ADDENDUM NO. 1

January 12, 2012

PROJECT: Etolin Street and Medical Campus Utilities Assistance

Section 02405 – Lift Station Check Valve and Flow Meter

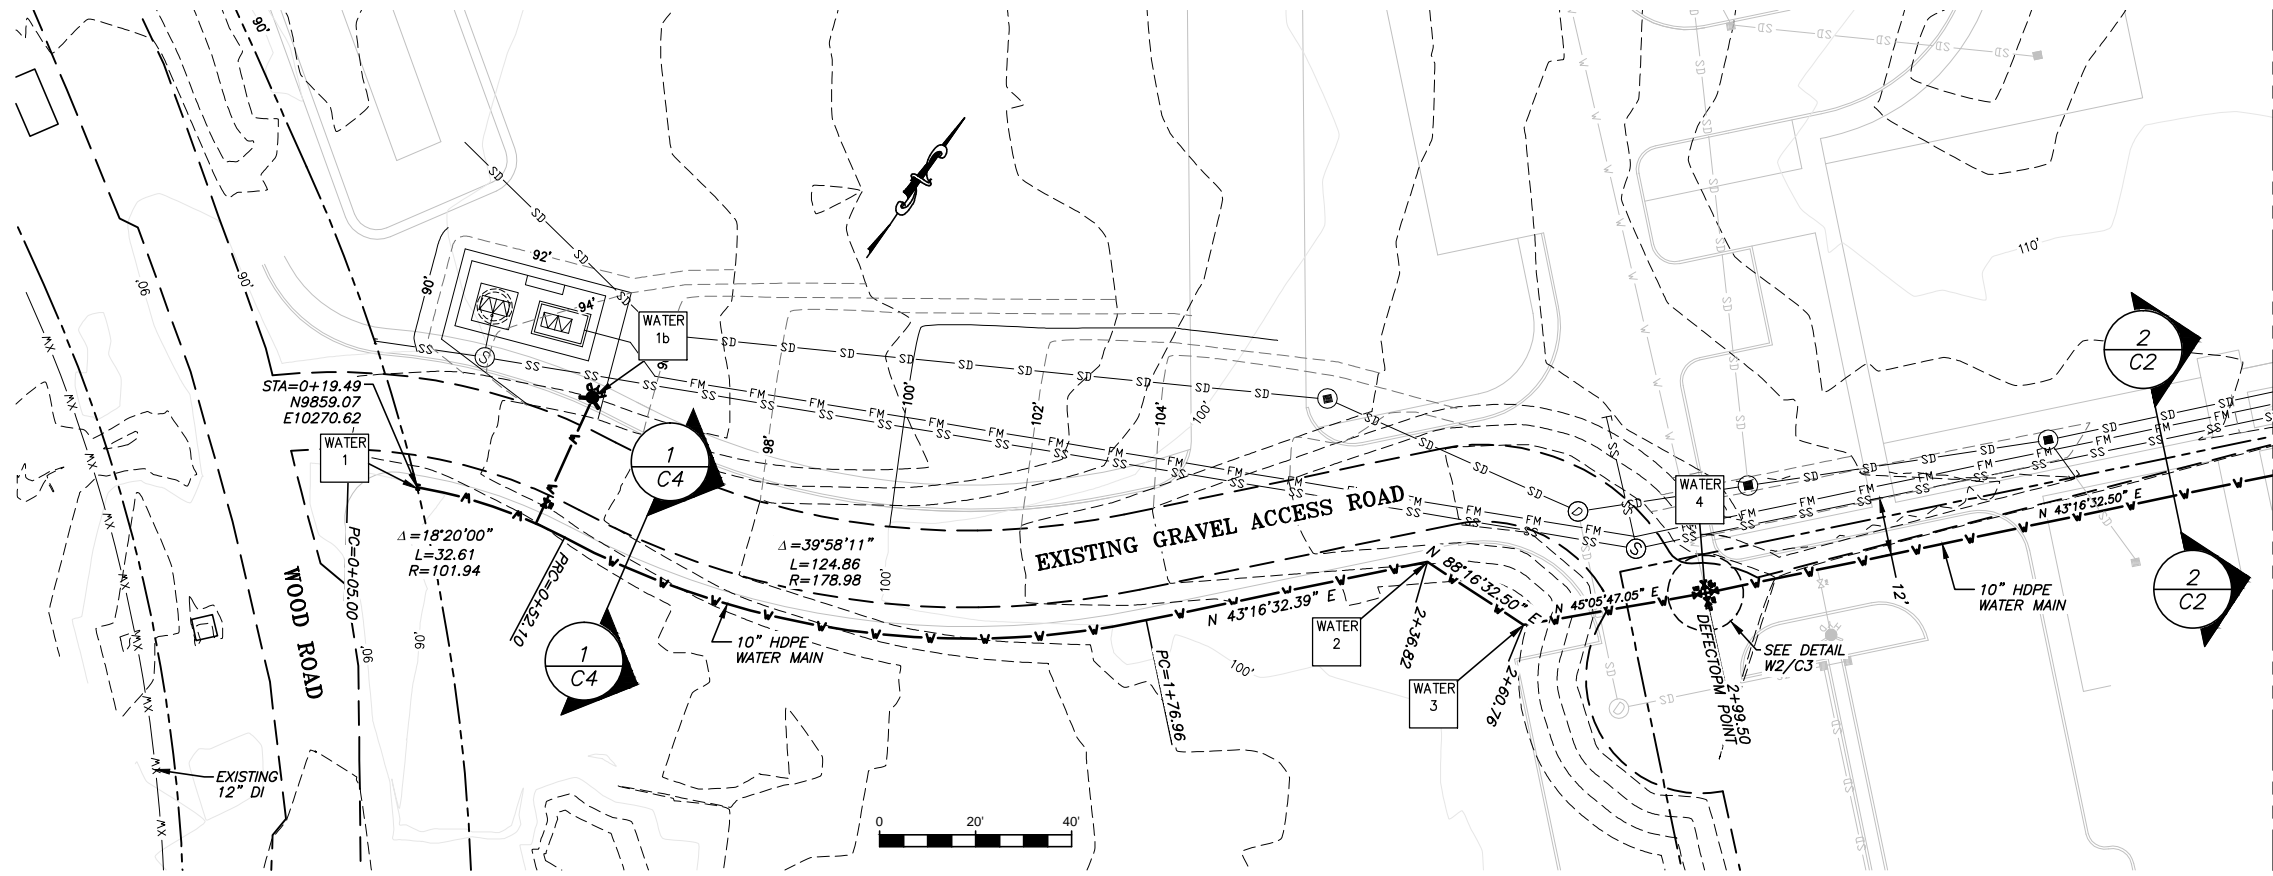
Add the following attached specification sections:

02405-Lift station Check Valve and Flow Meter

A reduced pressure zone assembly shall be installed to prevent back siphonage and back pressure backflow. Backflow device will conform to AWWA C511-92.

1. The assembly shall consist of pressure differential relief valve.
2. Check valves and captured springs.
3. Two tightly closing shutoff valves.
4. Valve shall have non rising stem
5. Valve shall have epoxy-coated cast iron bodies with bronze seats and stainless steel trim.
6. Valves shall be rated for 175 psi working pressure.
7. Valve shall be **Watt Series 909** or approved equal.

1. A flow meter will be installed up stream of the reduced pressure zone assembly. The flow meter will conform to ANSI/AWWA C701 specifications.
2. Operating Range shall be 30 to 2000 gpm.
3. Meter shall be Bronze with Magnetic Drive Turbo Drive.
4. Meter shall be equipped with a touch read system.
5. Meter shall be **Sensus Model W-2000 DRS**, or approved equal.
